Transmitter Receiver, Type T.R. 3173A (Stores Ref. 10DB/6022).—Replacement of Switch Unit, Type 208 (Stores Ref. 10FB/6007), by Switch Unit, Type 115 (Stores Ref. 10FB/556).

**Modification to Improve Gain Control and Output
Pulse Shape**

**A.R.I.5506 and A.R.I.5594—Indicating Unit, type 6E (Stores Ref. 10QB/141)
—Modification to improve the Calibration Setting up Procedure**

A.R.I. 5002, A.R.I. 5008, A.R.I. 5077, A.R.I. 5136, A.R.I. 5184,
A.R.I. 5506 and A.R.I. 5642—Indicating Units, type 96 (Stores Ref.
10QB/198) and type 260 (Stores Ref. 10QB/6374)—Replacement
of Condenser C2

DRG.N^o.C.D.0338/B Leaflet 2/44

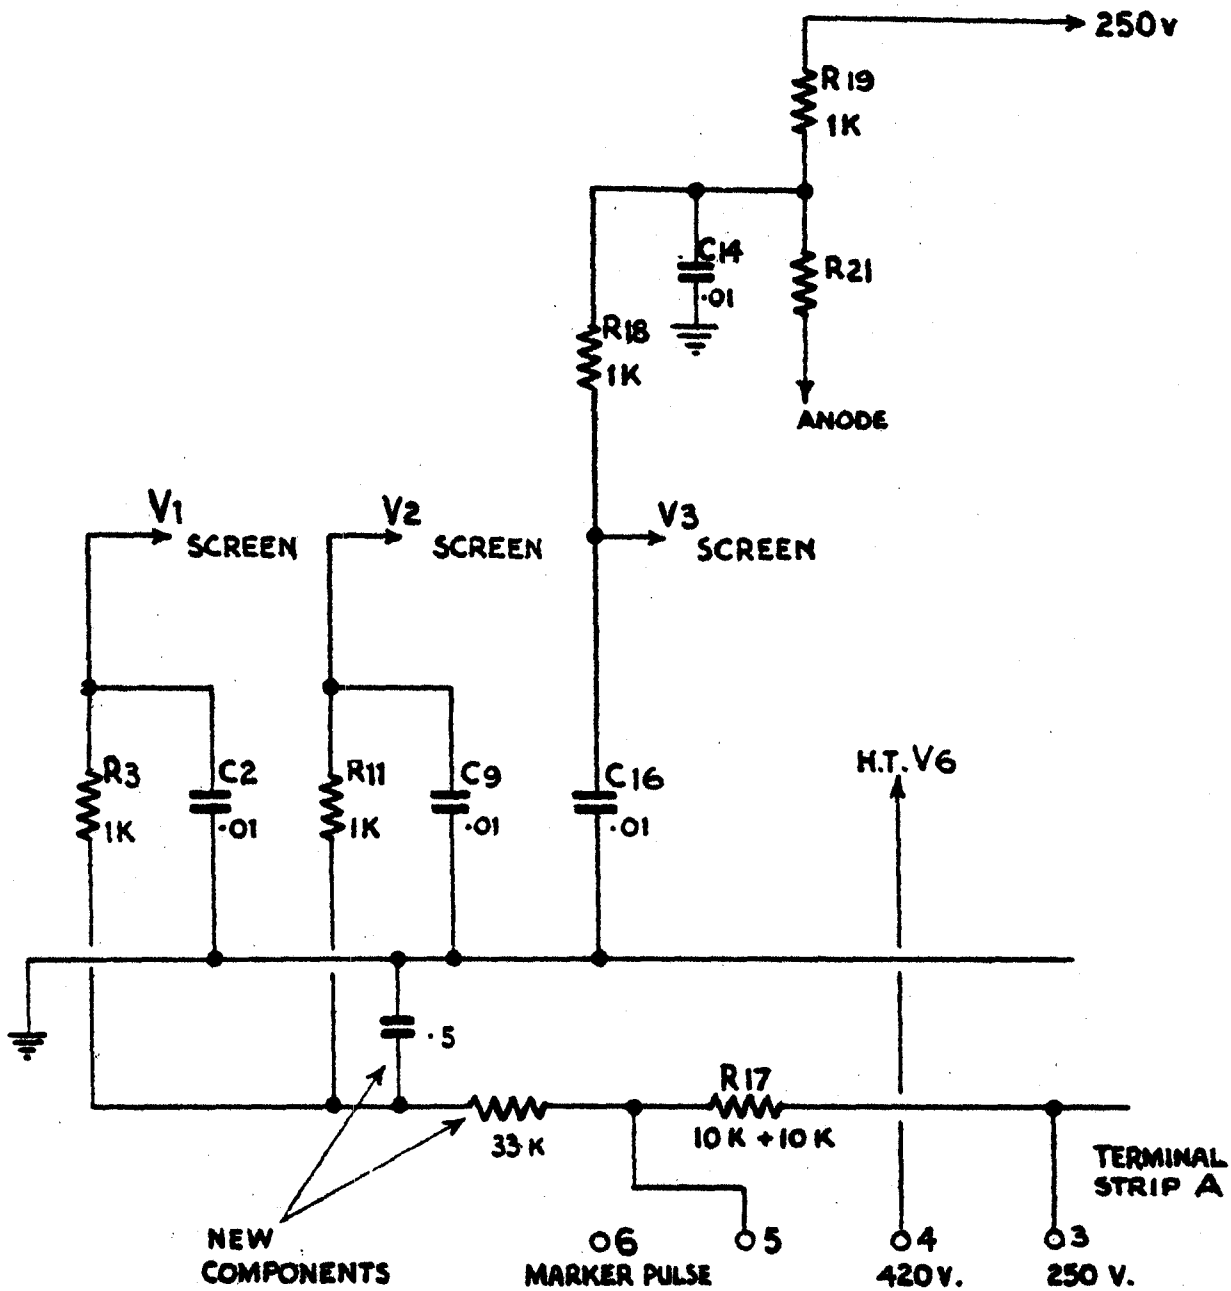
1. It has been found in service that the gain control circuit as originally embodied in the Amplifying Unit, Typ 178, used in Transmitter Receiver, type T.R.3173A, (Stores Ref. 10DB/6022) bearing serial numbers 201 to 400 (inclusive) does not provide a smooth enough action at its lower end, and that the maximum gain available is greater than is operationally necessary. This modification has the twofold purpose of decreasing the maximum over-all gain, and providing a smoother action at low values of gain. The alterations described in paras. 4(i)-4(iii) improve the gain control, while those described in paras. 4(iv)-4(vi) improve the output pulse shape.

4. Circuit references are to S.D.0338, Chapter 2, Fig. 8, and Drg. No. 0338, Ch.1, Leaflet 2, shows modified parts of the circuit. The modification is effected as follows :—

- (i) Locate the lead from R.17/10K +10K in series) to the 420V. H.T. line (tag 4 on the terminal Strip A). Disconnect this lead from the 420V. line and connect it instead to the 250V. line (tag 3 on the terminal Strip A).

- (ii) Locate the common junction point of R.3, R.11, R.17, which is connected by a lead to tag 5 on the terminal strip A. Disconnect R.17 and this lead from the junction. Connect one end of the 33K Resistance (Type 726 or 1799) to the junction of R.3 and R.11, and the other end to the: junction of R.17 and the lead which goes to tag 5.

- (iii) Connect the Condenser, Type 3367 (0.5 η F.), between earth and the junction of R.3, R.11 and the 33K resistor.
- (iv) Remove the 0.01 ν F. condenser C.38 connected between the cathode of V.6 and earth.

- (v) Remove the lead which connects the junction of R.32, R.45 to tag 6 on the terminal strip A.
- (vi) Remove the connection between terminals A6 and M7 on the base plate.

DRG. NO. A.P.2914 B / 6 / 45

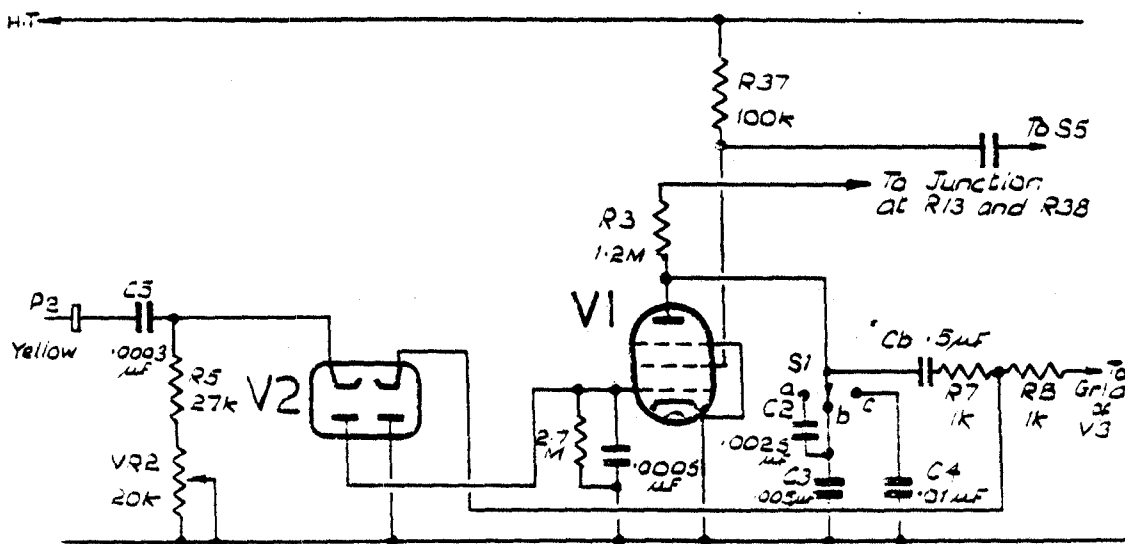
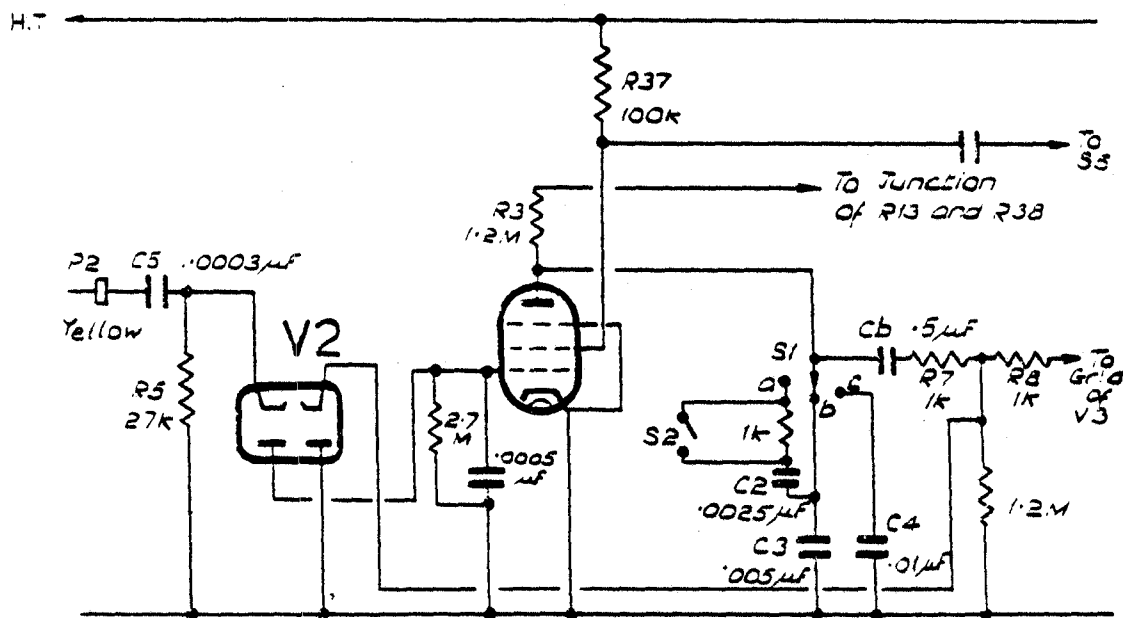
(Refer to fig. 14, CD.0338-B, and to Drg. No. A.P.2914B/6/45.)

(i) Remove VR2 and correct R5(27K) to earth. (It should be noted that the input circuit in CD.0338B, fig. 14 is incorrect and reference should be made to the drawing.)

(ii) Remove R9 and replace it by VR2 connected as a variable resistor.

(iii) Disconnect the contact "b" on switch S5 from contact "a" and reconnect it to contact "c" on the same switch. (Contact "a" is now connected to R15 and contacts "b" and "c" to C20.)

(iv) Insert between contact "a" of S1 and C2 a resistance, type 500 (Stores Ref. 10W/11667).

(v) Remove the switch S2 in parallel with R36 and re-connect it in parallel with the resistance, type 500 (Stores Ref. 10W/11667) referred to in operation (iv).

(vi) Insert a resistance, type 2161 (Stores Ref. 10W/8687), between earth and the junction of R7 and R8.

(a) BEFORE MODIFICATION

(b) AFTER MODIFICATION.
